Montecillo Unit Eleven Replat H

City Plan Commission — June 18, 2025

SUMMARY OF RECOMMENDATION: Staff recommends **APPROVAL** of Montecillo Unit Eleven Replat "H" on a Resubdivision Combination basis.

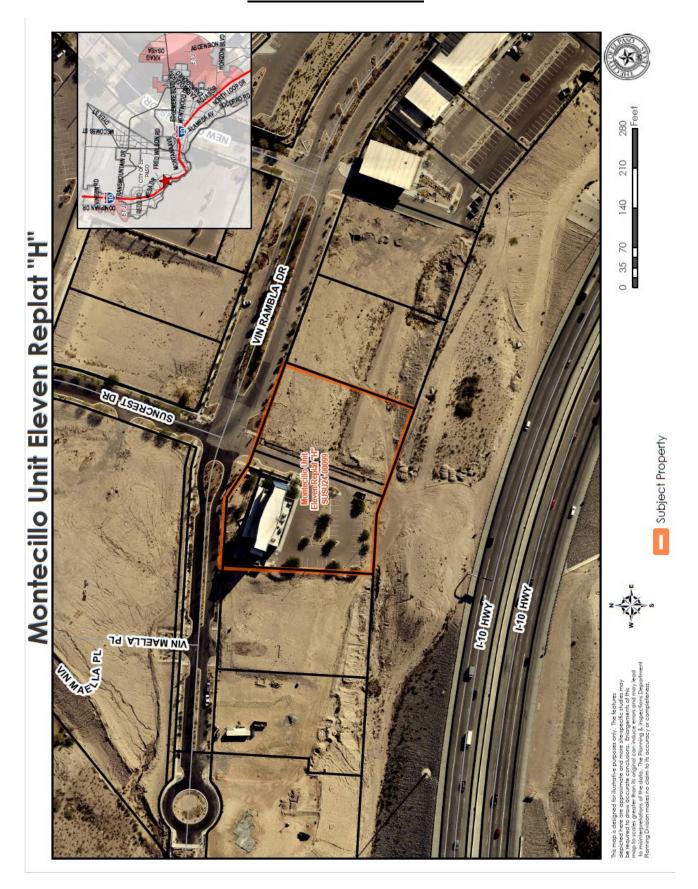
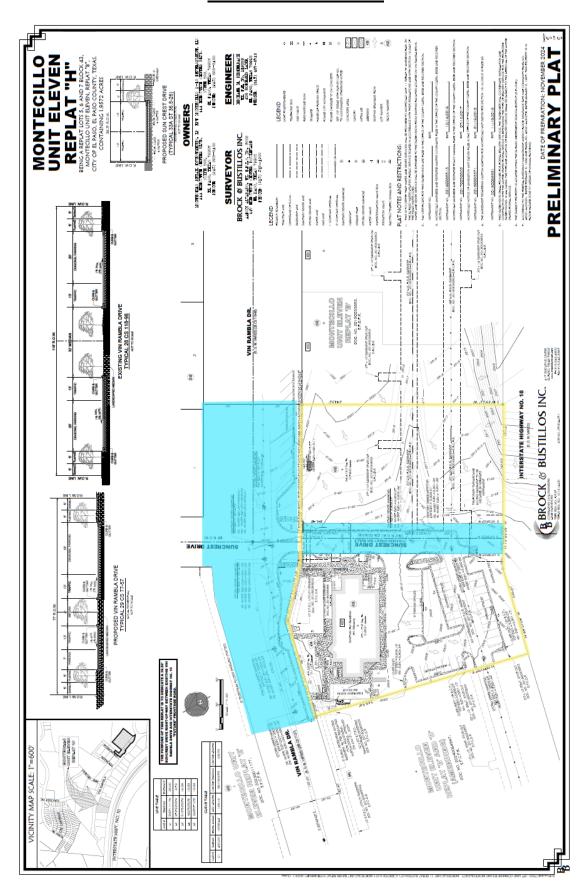
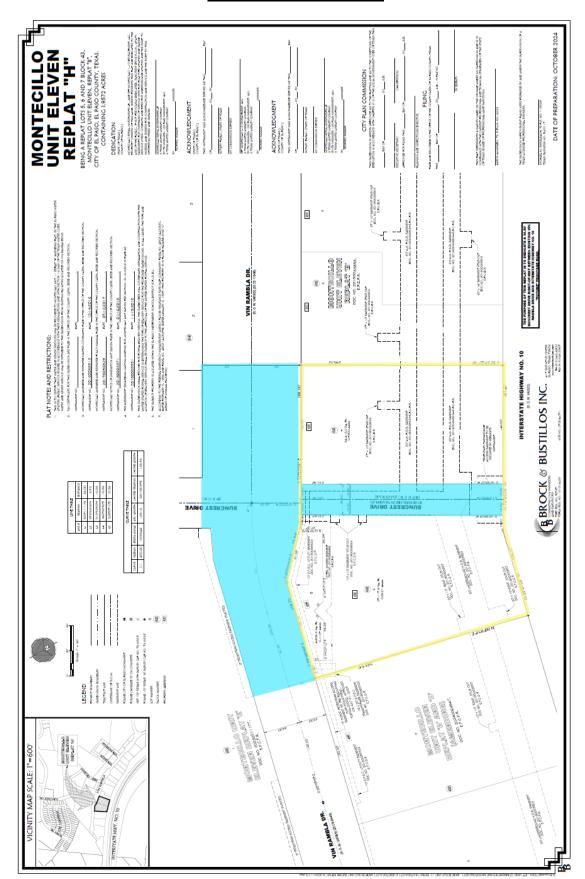
- 1. Label Sun Crest Drive on plant view as "dedicated by this plat" on final plat sheet.
- 2. Show the proposed street lights, stripes, and signage for proposed street.

- 7. Illustrate a planting swale on typical street cross section for Sun Crest Drive.
- 8. Clarify Suncrest Drive street centerline offset distance dimension.
